Model: Model CM-C2	Date: 24-Aug-07	No.: RG960001a
--------------------	-----------------	----------------

Subject: Firmware history (Local)		Prepared by: Y.Gaman	
From: Technical Services Sec., Service Planning Dept.			
Classification:	<input type="checkbox"/> Troubleshooting <input type="checkbox"/> Mechanical <input type="checkbox"/> Paper path <input type="checkbox"/> Product Safety	<input type="checkbox"/> Part information <input type="checkbox"/> Electrical <input type="checkbox"/> Transmit/receive <input checked="" type="checkbox"/> Other ()	<input checked="" type="checkbox"/> Action required <input type="checkbox"/> Service manual revision <input type="checkbox"/> Retrofit information <input checked="" type="checkbox"/> Tier 2

Model: CM-C2		Date: 15-Jan-09	No.: RG960003
Subject: Service Manual Correction		Prepared by: Y.Gaman	
From: 1st Tech. Support Sec. Service Support Dept.			
Classification:	<input type="checkbox"/> Troubleshooting <input type="checkbox"/> Mechanical <input type="checkbox"/> Paper path <input type="checkbox"/> Product Safety	<input type="checkbox"/> Part information <input type="checkbox"/> Electrical <input type="checkbox"/> Transmit/receive <input ty

Section 6: Detailed Descriptions

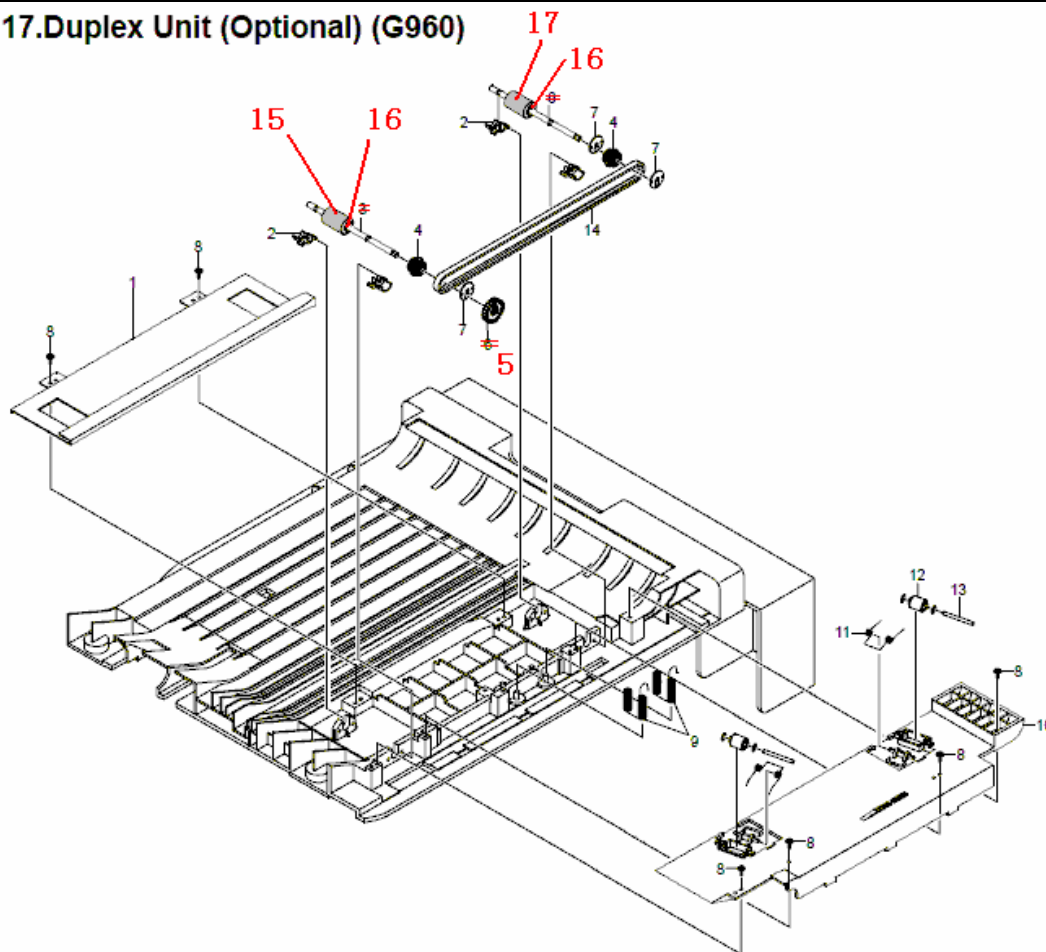
Descriptions for New Toner Detection and Toner End Detection were added.

The machine does not have a toner end sensor. The machine checks the amount of toner with software. The machine counts and adds up black dots as toner consumption. For example, the following occurs when the machine prints 5% of black rate chart

When the total number of dots gets to a pre-programmed figure (as for toner near-end), the machine shows "TONER LOW". After another period of dots has been counted up, the machine finally shows "TONER EMPTY" (as for toner end), and the machine stops printing. You can check the total dot counts from the current cartridge in the System Data List in TECH mode.

6.Frame Assembly (G960)

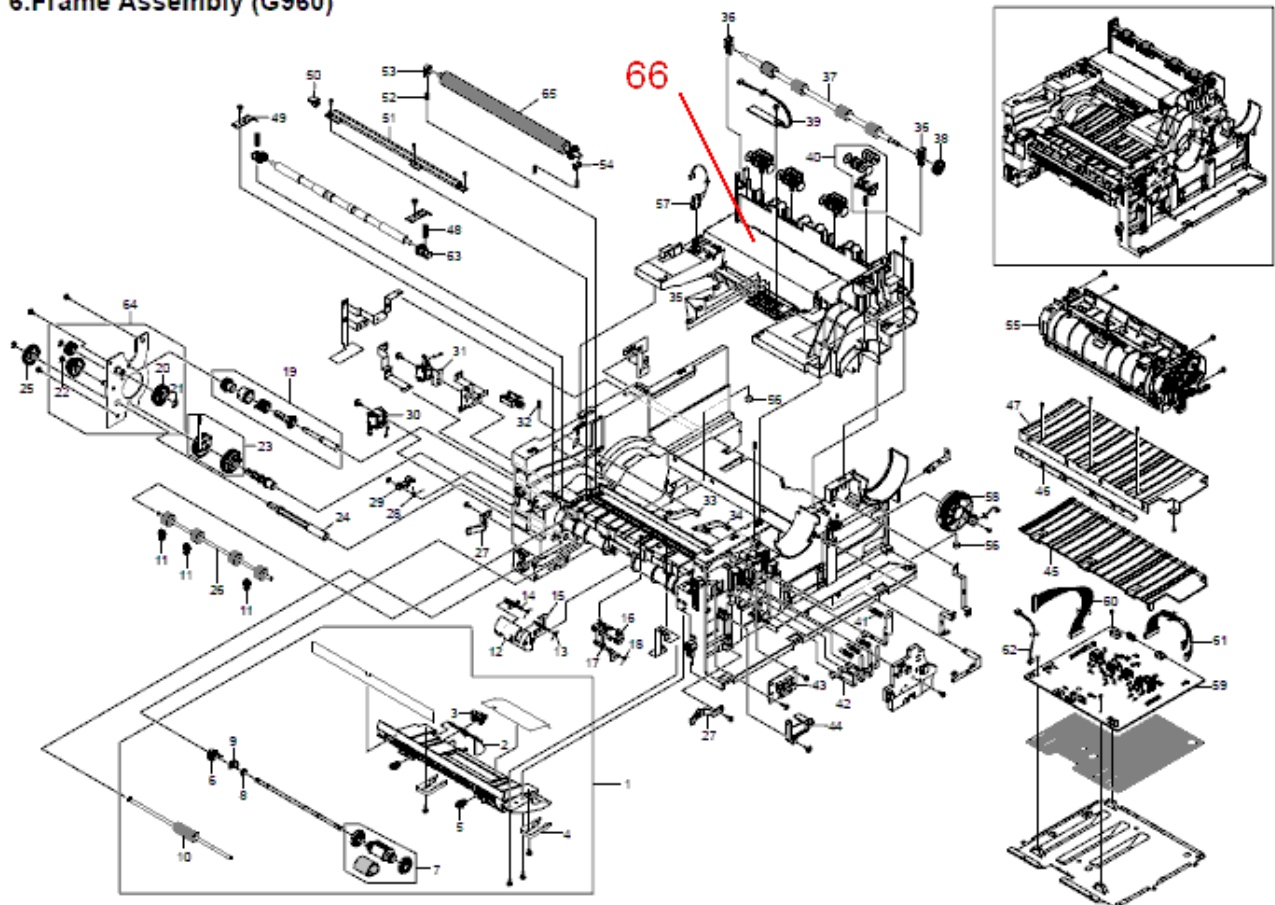
New part number	Description	Q'ty	Int	Page	Index	Note
G9601258	FRAME-M_EXIT	1	-	13	66

Change: This part was added.

Reason: Requests from the field.

1.Main Exploded Views (G960)

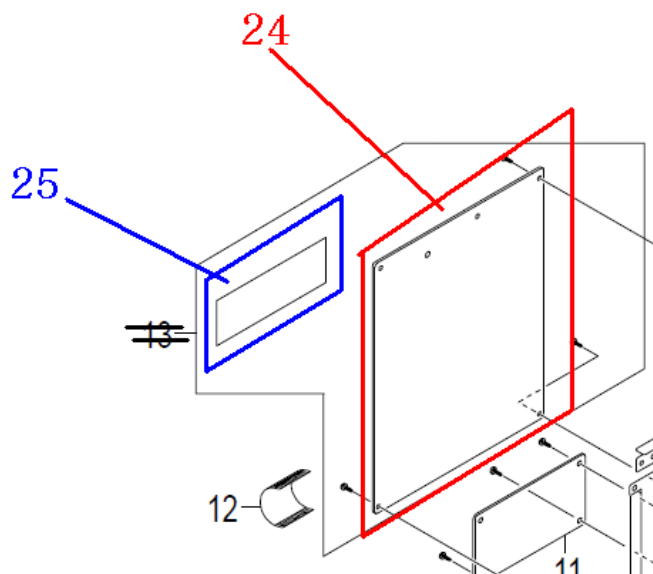
The main board assembly is divided into two separate parts as follows:

Old part #	New Part #	Description	Q'ty	Int	Page	Index	Note
G9601375	G9601454	Main Board	1	O/O	3	13→24	
	G9601460	SDRAM	1	O/O	3	25

Page 8 of Parts Catalog:

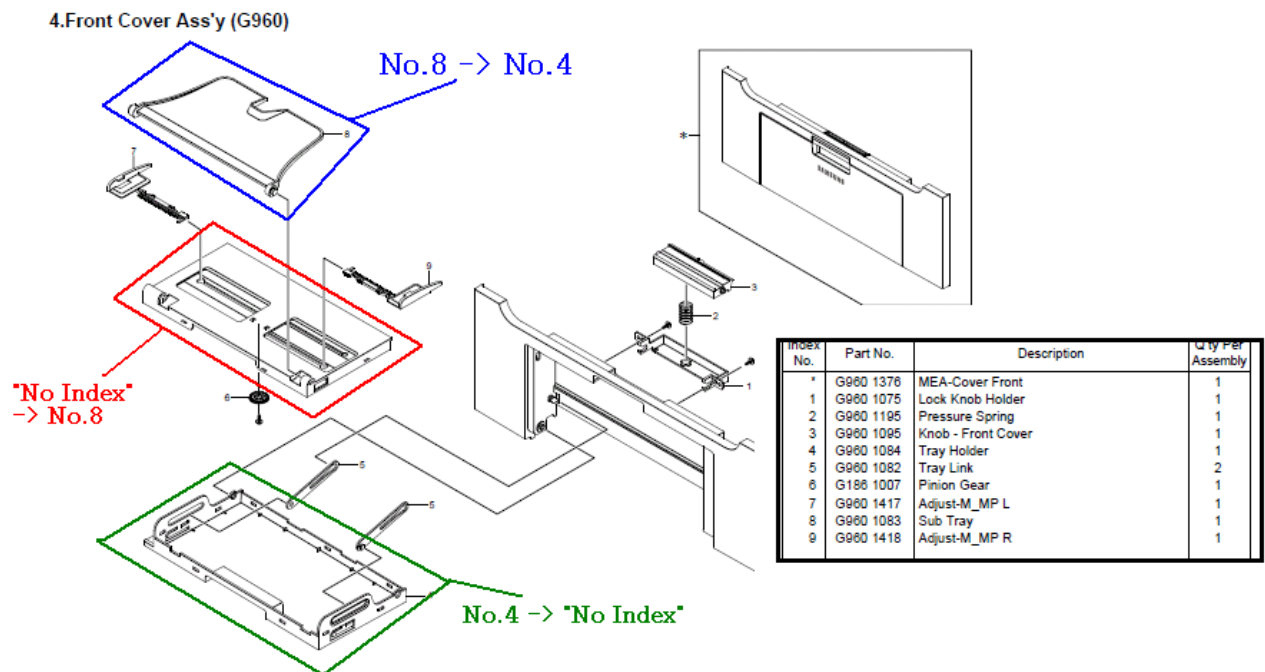
The indices of the following parts are corrected.
